EC07-013

ITB08-011

February 22, 2008

2008 G37; RELAY BOX UPPER COVER REPLACEMENT

Figure 1

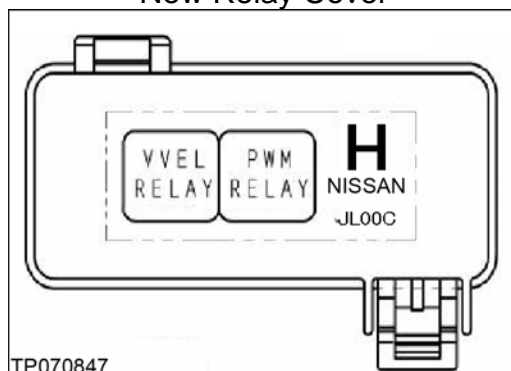
If you are diagnosing issues related to the VVEL system or power to the radiator fans, be advised the relay cover is incorrectly labeled as shown in Figure 1. Refer to Figure 2 for the correct relay cover.

NOTE: Remove and replace the relay box upper cover shown in Figure 1 with the relay box upper cover listed in the Parts Information section of this bulletin and displayed in Figure 2.

DESCRIPTION	PART #	QUANTITY
Relay Box Upper Cover	24382-JL00C	1
